# BULLETIN

Bulletin No. 100

**SUBJECT:** PA-12 Cowling Interference

FIGURE 1  
COUIL BRACE INSTALLATION

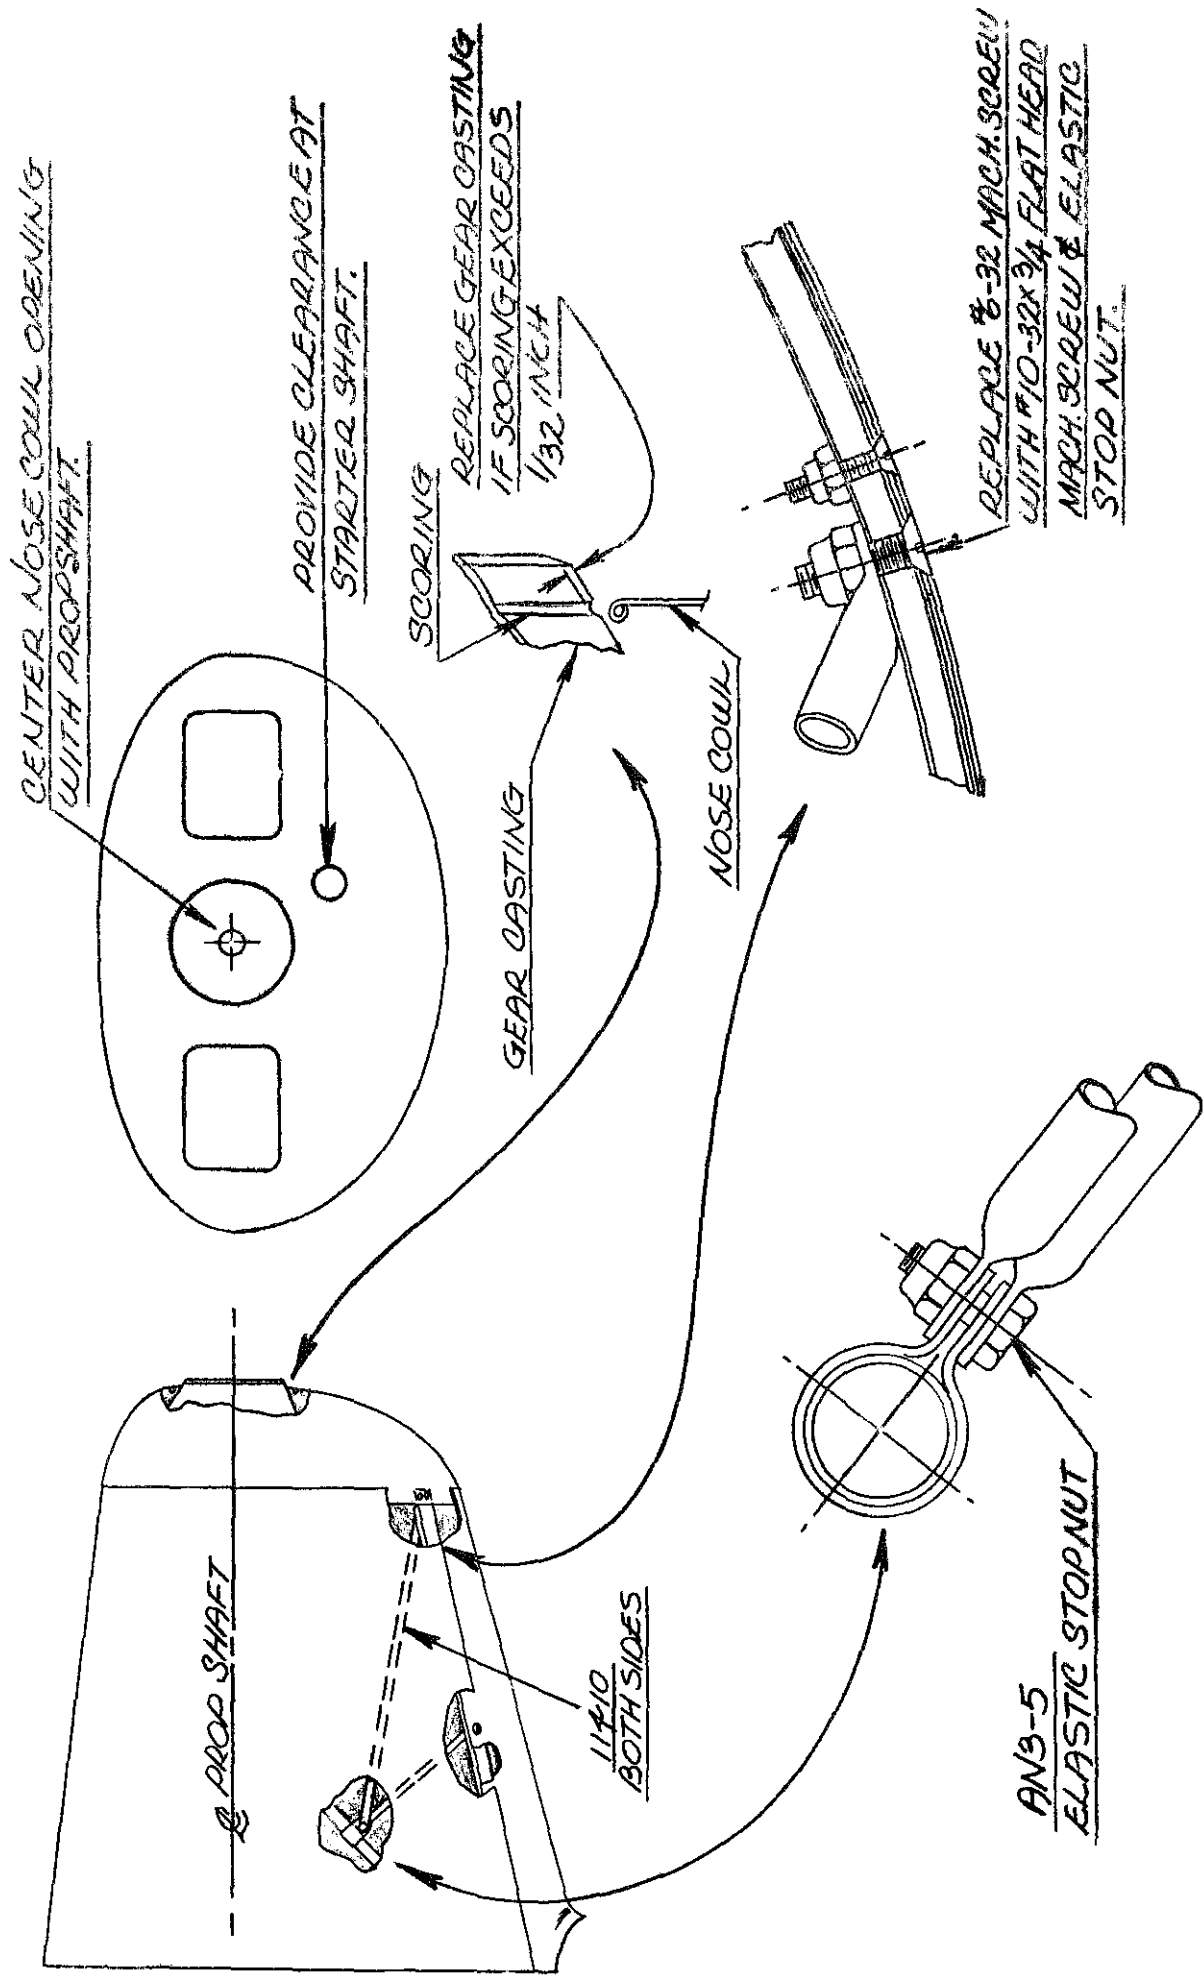
Some difficulty has been experienced with the PA-12 Cowl attachments loosening and allowing the nose cowl to bear against the starter ring-gear casting near the propeller hub; in some cases, actually severing the casting.

To prevent the occurrence of this difficulty, we recommend that additional braces Part No. 11410 be installed according to the sketch shown on opposite side of this bulletin. These parts are available through your local Piper dealer or distributor.

A general tightening of all cowl attachments is also advised, and particular care should be exercised to "center" the cowl opening with the propeller shaft. Clearance at the starter shaft also should be assured.
